Planning Commission Regular Meeting December 15, 2022 7:00PM City Hall 102 Butler Street, Saugatuck, MI

City of Saugatuck Planning Commission

Memo Date:	December 8, 2022	Meeting Date:	December 15, 2022
Request:	Site Plan Review	Applicant:	JPD Construction
Address:	383 Dunegrass Cir.	Project Name:	Dunegrass Residence
Parcel:	57-077-019-00	Plan Date:	May 20, 2022
Acreage:	.43	Zoning District:	PUD/CRC
Complete:	Yes	Recommendation:	Conditions noted
Staff:	Ryan Cummins	Consultant:	David M. Jirousek, AICP

SITE PLAN SCALE: 3/32" = 1'-0"

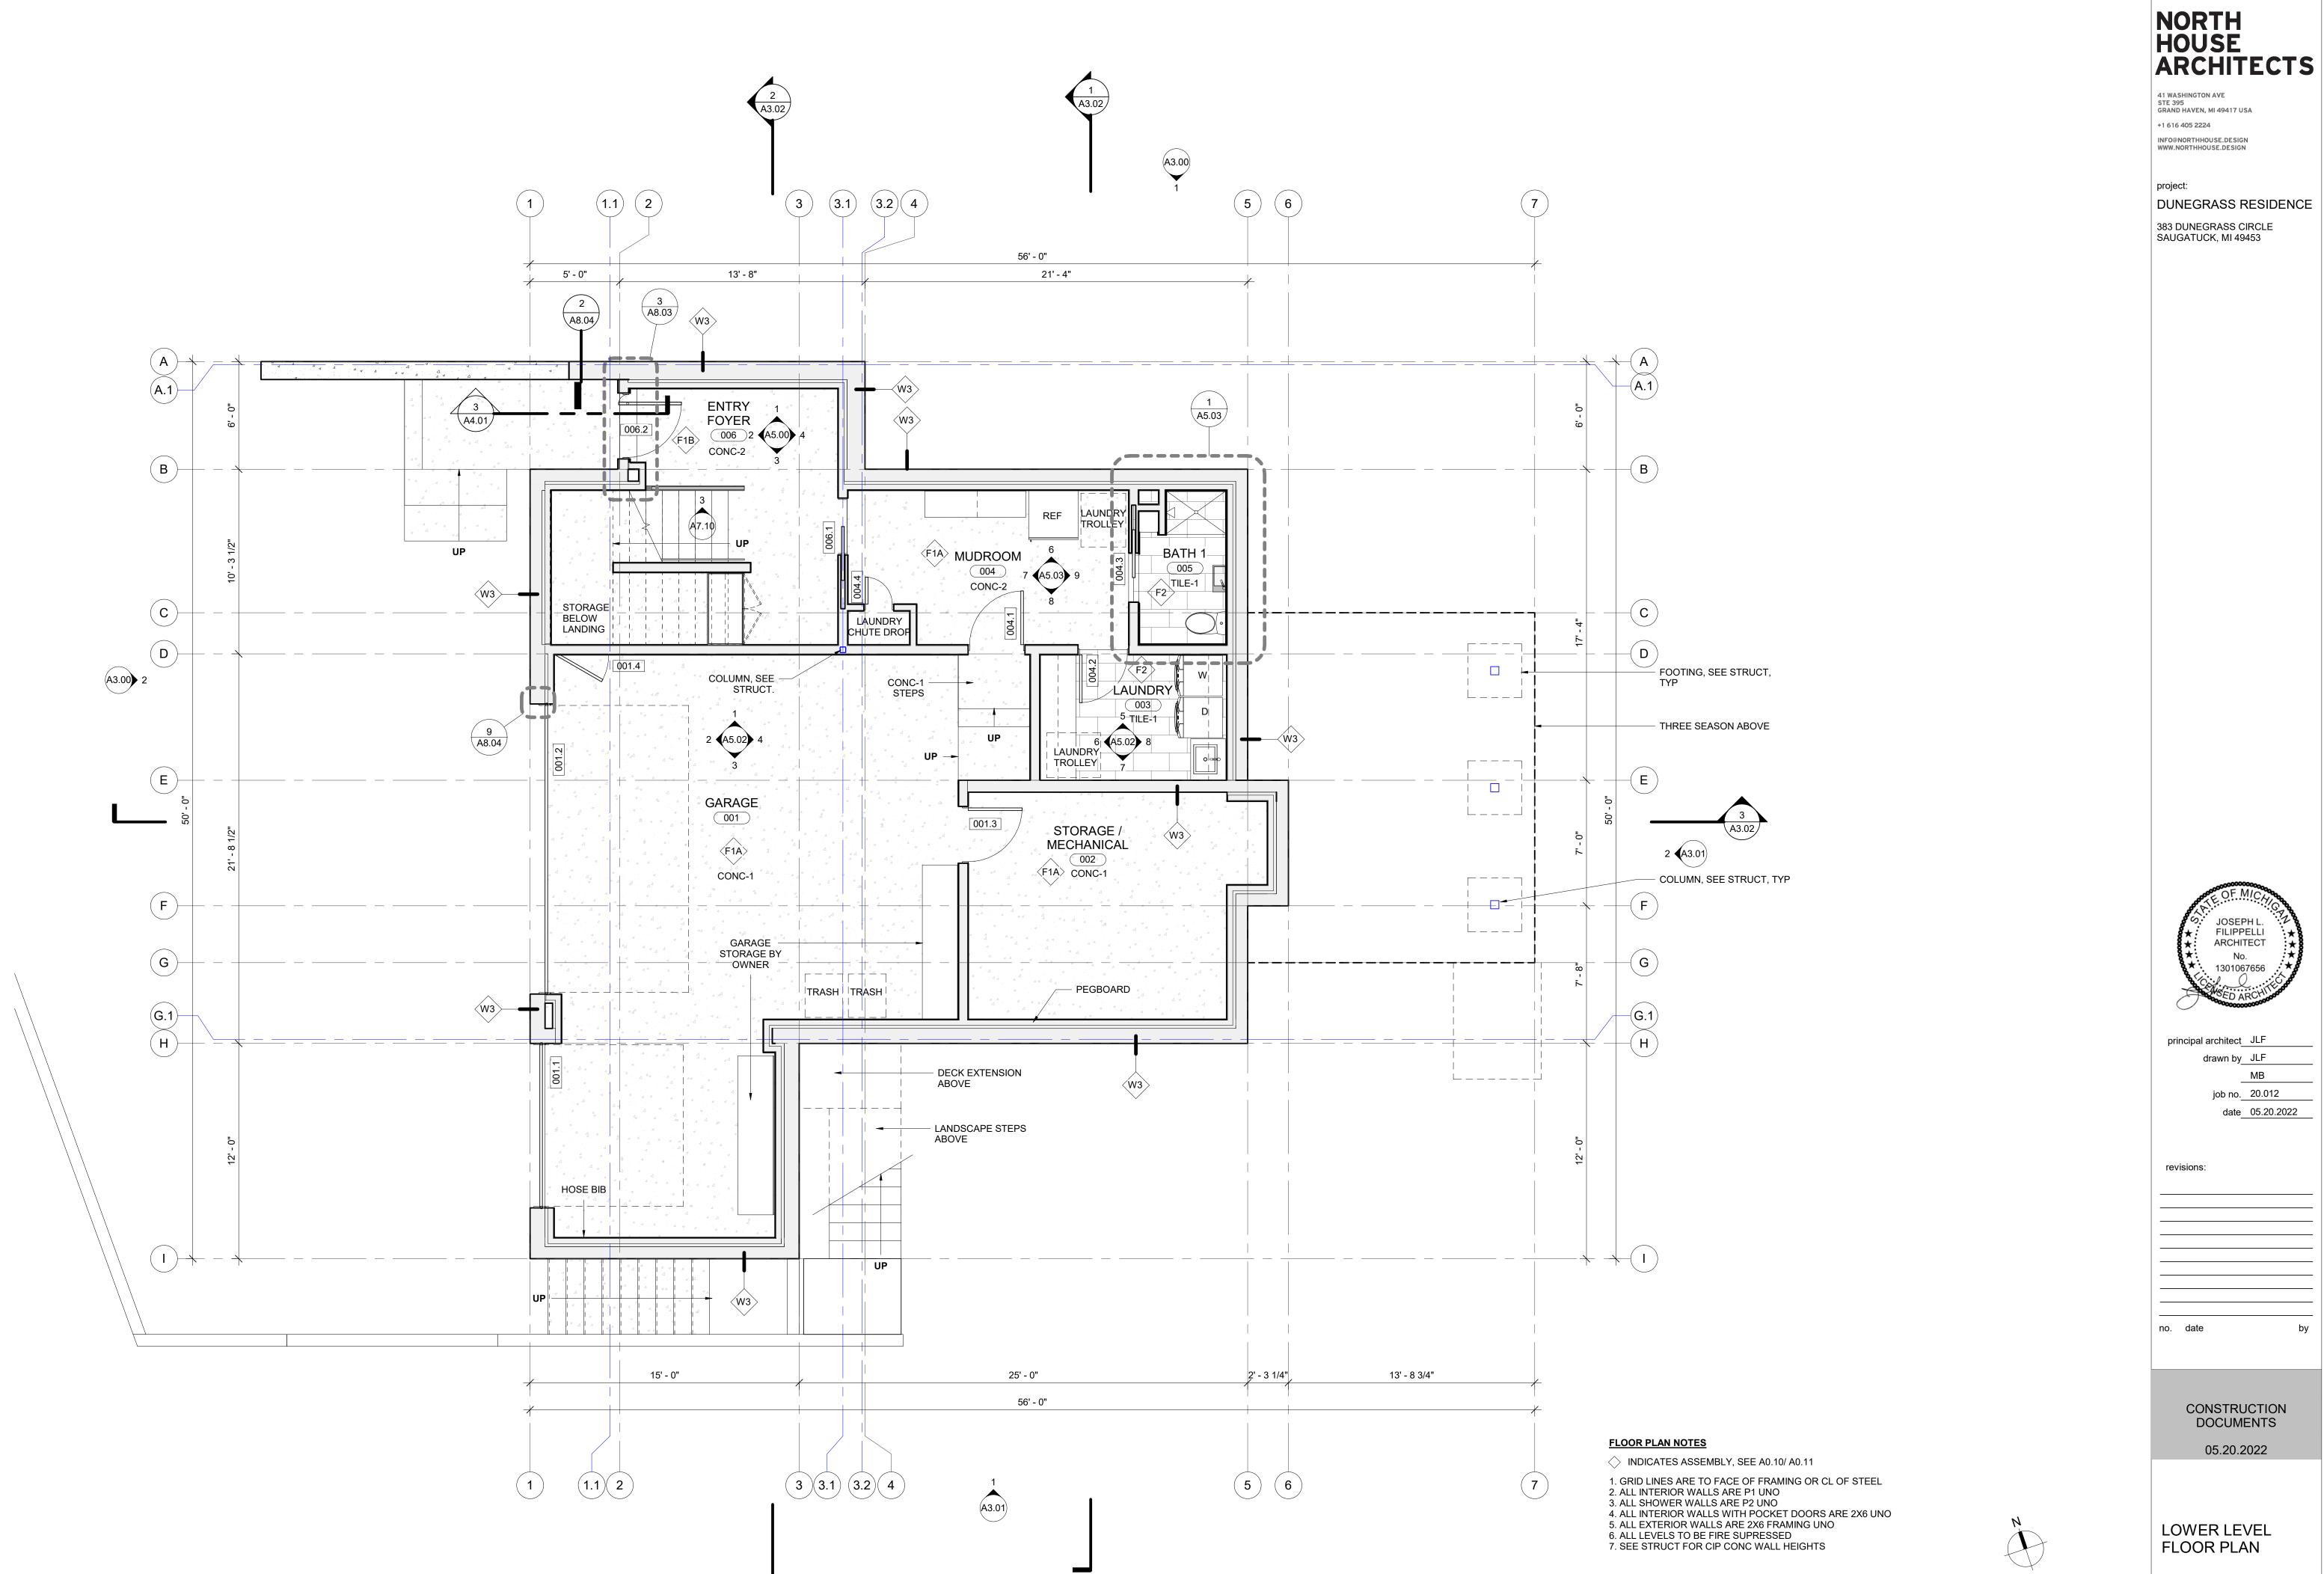
<u>Setbacks</u>. The PUD plan indicates that setback modifications were approved as part of the overall PUD process. The proposed building envelope and footprint that are shown on the site plan comply with the setbacks noted on the PUD plan (20' front, 5' side, and 10' rear).

The 0.43-acre lot is 18,731 square feet, and the building footprint is 1,545 square feet. As such, the lot coverage is 8.2%, which exceeds the 5% required in the underlying Conservation, Recreation, and Camp District (CRC). Lot coverage modification was not specifically requested during the 2015 PUD application.

The original PUD plan shows unit 19 as .80 rather than 0.43 acres. A portion of unit 19 is noted as a limited common element included in the .80 acres. If considered with the limited common element, lot coverage would be compliant. However, unit 19, as surveyed and legally defined, is .43 acres.

The deviation between the PUD plan and the site condo survey appears to have inadvertently resulted in a compliance issue. However, the Planning Commission may have additional background regarding the site condo approval process, the discrepancy, and whether unit 19 and the limited common element were intended to be counted as one for the purpose of this requirement.

Comment: The building site and driveway are proposed to be located on the most level portion of the site, and the single-family dwelling is built into the slope giving it the appearance from the north as a two-level building. However, the lower level allows for a drive-out garage and walk-out basement.

Comment: The proposed area of disturbance shown on the site plan appears to limit the overall impact of site work. Alterations to the topography appear to be the minimum necessary to provide the most appropriate building site within unit 19. However, it should be noted that the owner is currently subject to an "Order to Restore" from the Michigan Department of Environment, Great Lakes, and Energy (EGLE) Water Resources Division (WRD) based on recent clearing and stump grinding. EGLE has provided the owner with a directive to restore vegetation to ensure compliance with Part 353, Sand Dune Protection and Management, of the Natural Resources and Environmental Protection Act, 1994 PA 451, as amended

Comment: Existing vegetation outside of the limits of disturbance will provide visual screening from the road and units to the east. There will be no screening of the west side of the dwelling from unit 18. However, screening was not intended between units 18-19 based on the shared driveway shown on the PUD plan (see plan on page 2).

Comment: The Fire Department must review the site layout regarding site access and the ability to respond to emergencies. It appears that the driveway design was approved by the

Fire Department on February 10, 2022, based on a note on the site plan. However, this approval should be confirmed.

Comment: As stated earlier, the U-shaped drive from Dunegrass Circle Drive was approved in concept as part of the 2015 PUD plan. Driveway and private road details were included on the plan sheet C-102A.

Comment: Due to the sandy soils within the PUD, stormwater detention was not required. Rainwater is proposed to be collected by gutters and downspouts and conveyed to a leach basin.

The two primary compliance issues are lot coverage and building height. If those issues are addressed and compliance confirmed, the site plan could be approved with the following conditions:
